SBN-395  
T.F. B7.1.2

Subject: Revised Response to RAI 281.6; Post-Accident Sampling;  
(Chemical Engineering Branch)

RAI 281.6 (9.3.2, NUREG-0737, II.B.3)

9.3.2 Process Sampling System

SD NO. 30

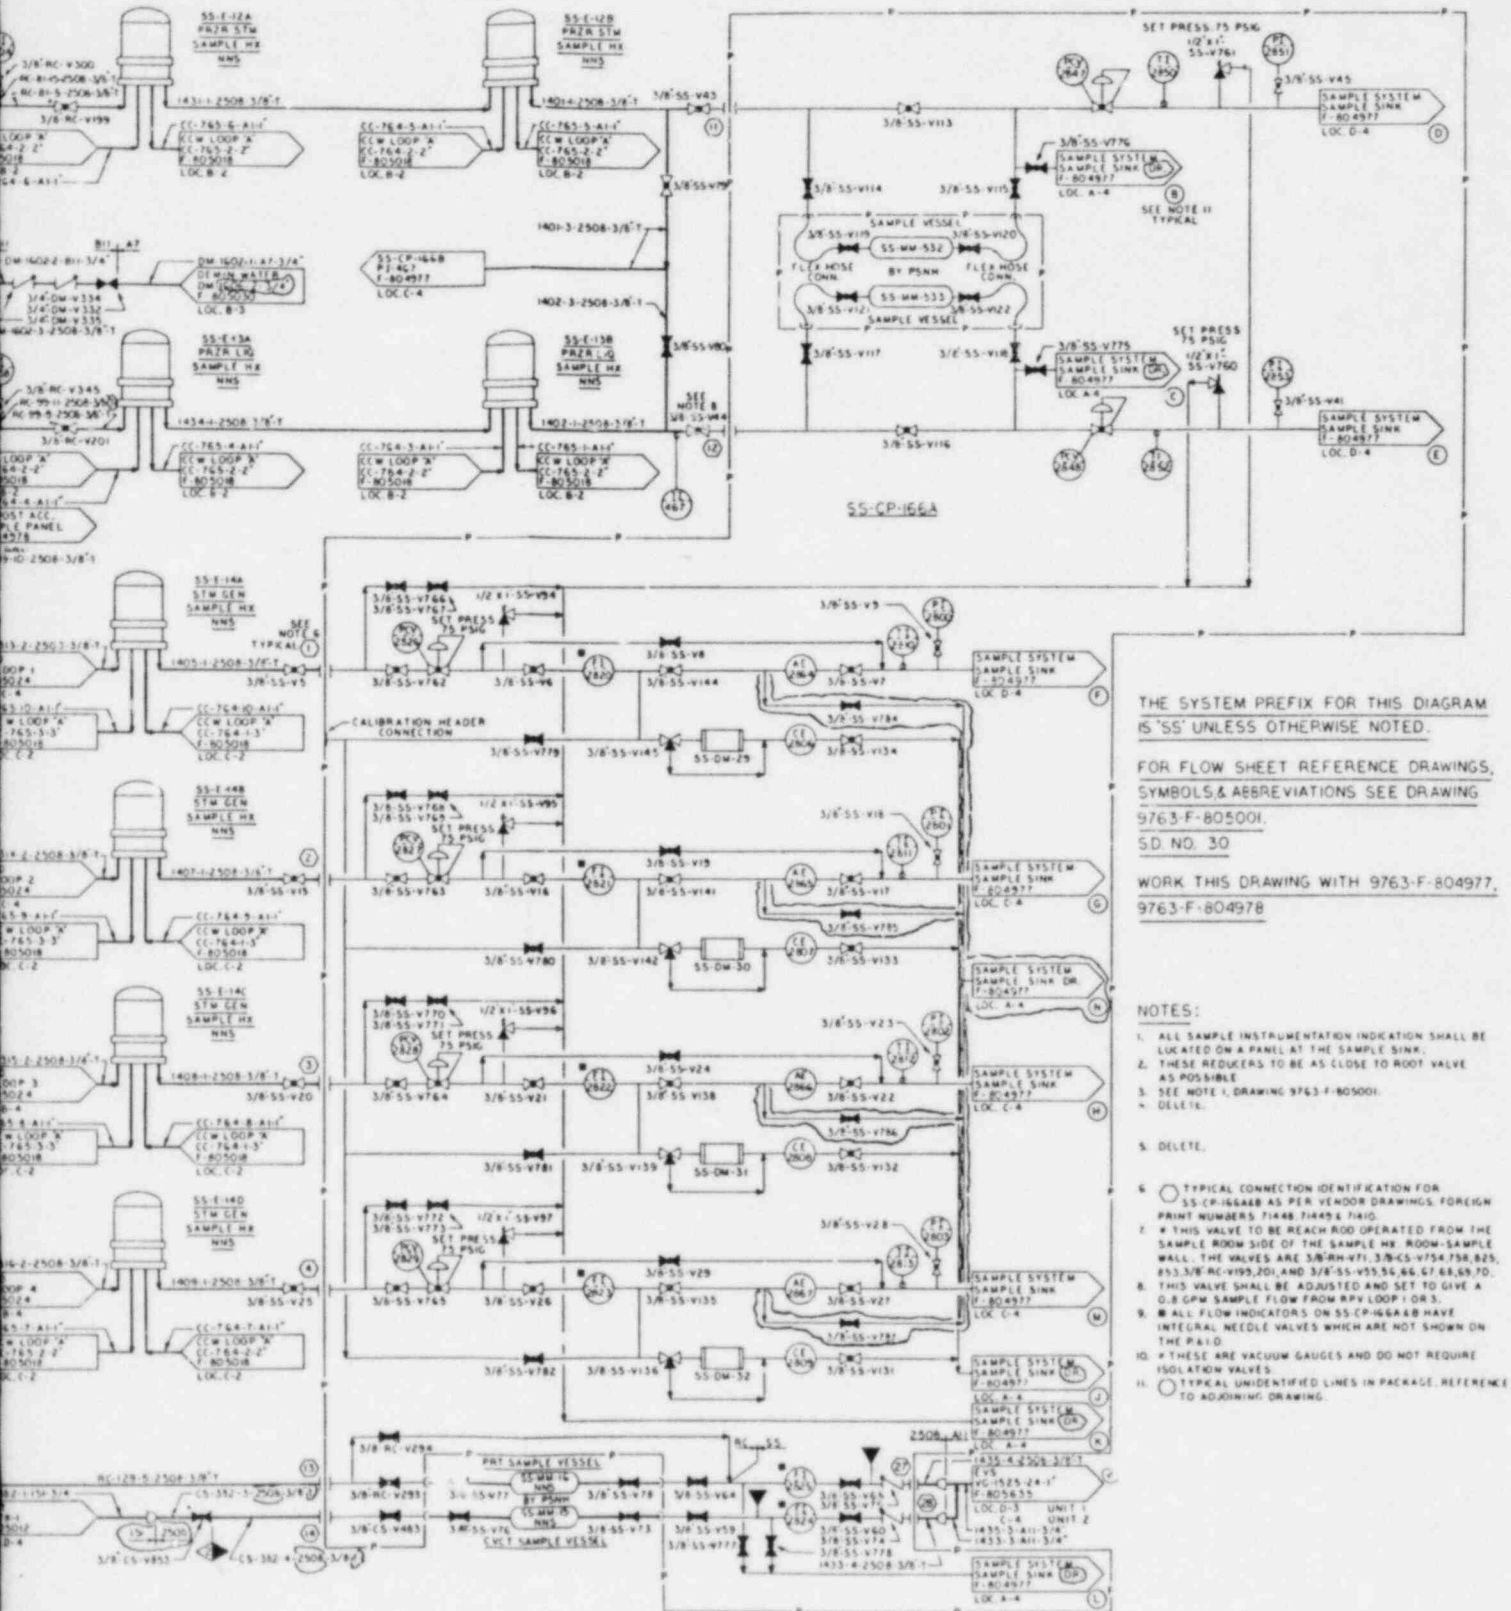
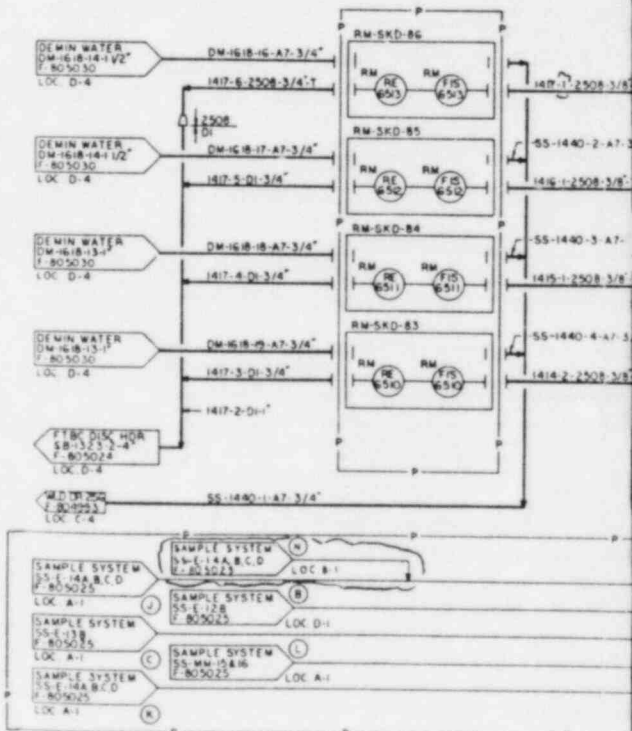
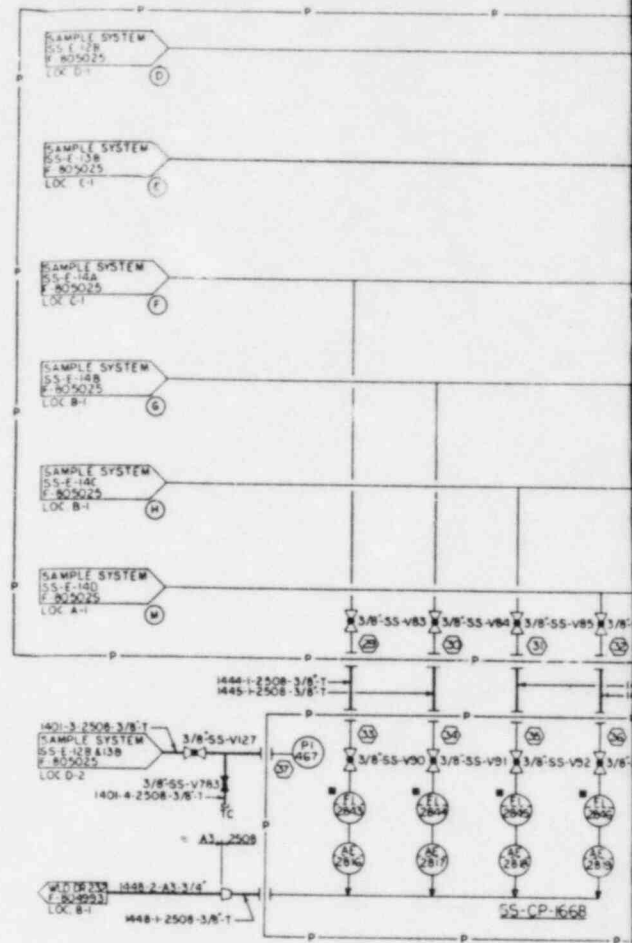
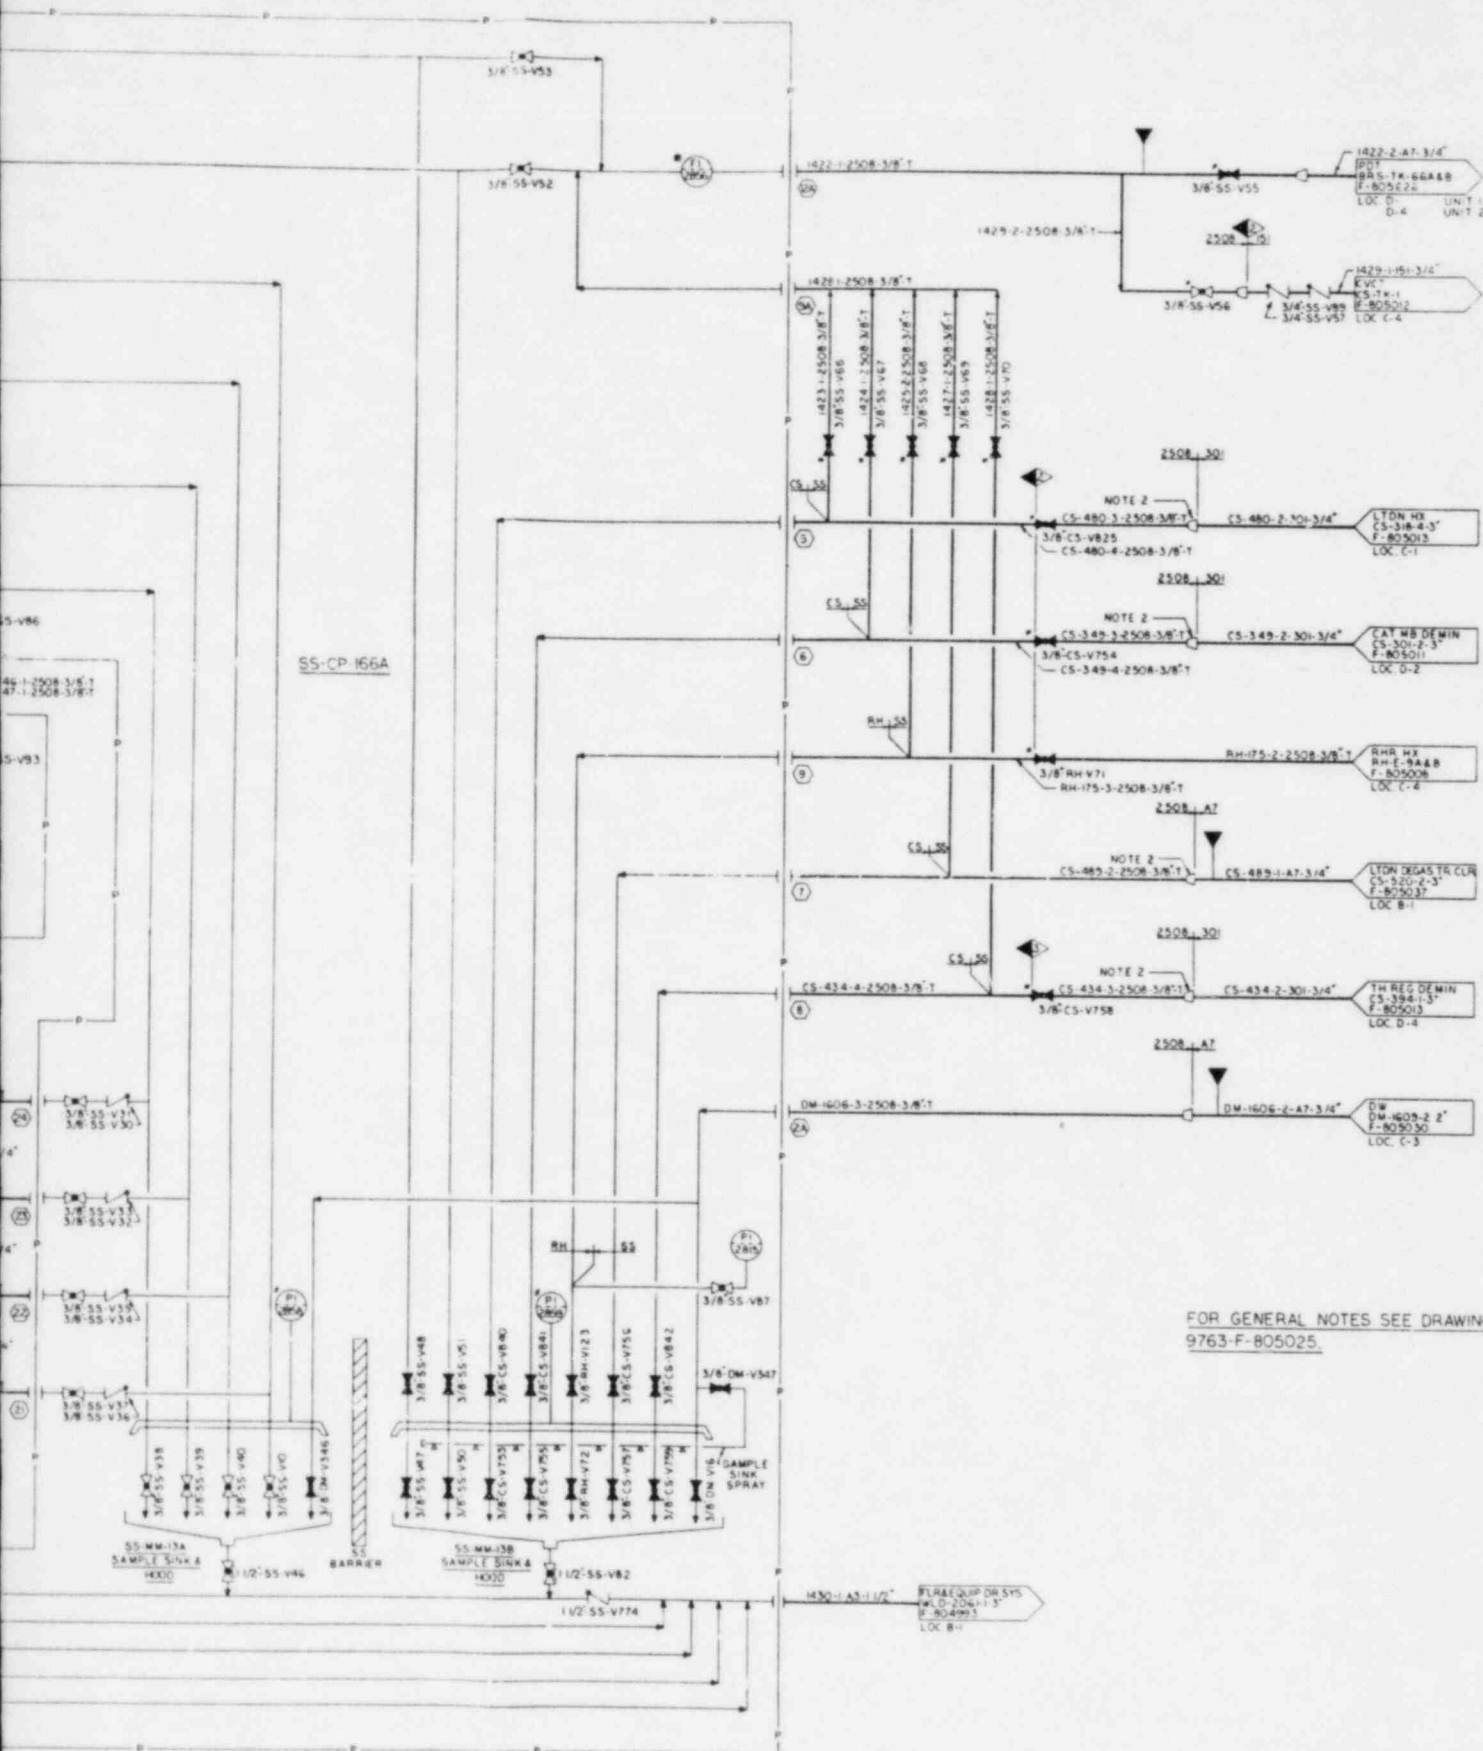
Heat exchangers, vessels, piping, fitting and valves are designed, procured and installed in accordance with ASME Boiler and Pressure Vessel Code, Sections III, VIII, and ANSI B31.1. Safety class descriptions of the various components are indicated on the system P&IDs ~~(see Figure 9.3-5a)~~ (see Figures 9.3-5a, -5b, -5c) for the reactor coolant, steam generator and other auxiliary systems sampling subsystems. The components of the secondary steam and water sampling subsystem are non-nuclear safety class (NNS).

~~SEE FIGURES 9.3-5a, -5b, -5c~~

~~See Figure 9.3-5~~ for those samples routed to a central sampling point. The locations of the sample points are shown on the appropriate system piping and instrumentation diagrams for the system to be sampled. Sample points for the secondary steam and water sampling subsystem are also shown diagrammatically on Figure 9.3-6.

The post-accident sample system is designed such that the flow through the sample lines is turbulent in order to reduce plate out. In addition, these lines can be flushed with demineralized water after a sample is taken. The post-accident sample system also allows for collection of an adequate volume of fluid which results from purging the sample lines in order to obtain representative samples. Provisions exist which enable samples to be returned to the containment, even if pressurized.

## 5. Post-Accident Sampling Subsystem

The post-accident sampling subsystem provides the capability to obtain liquid samples from reactor coolant loops 1 and 3, ECCS pump room sumps, the pressurizer relief tank, the containment recirculation sumps and gas samples of the containment atmosphere under post-accident conditions.

The reactor coolant sample line used during post-accident operation branches off the common line from loops 1 and 3 inside the primary auxiliary building. This line bypasses the sample heat exchangers and runs directly to the post-accident sample panel.
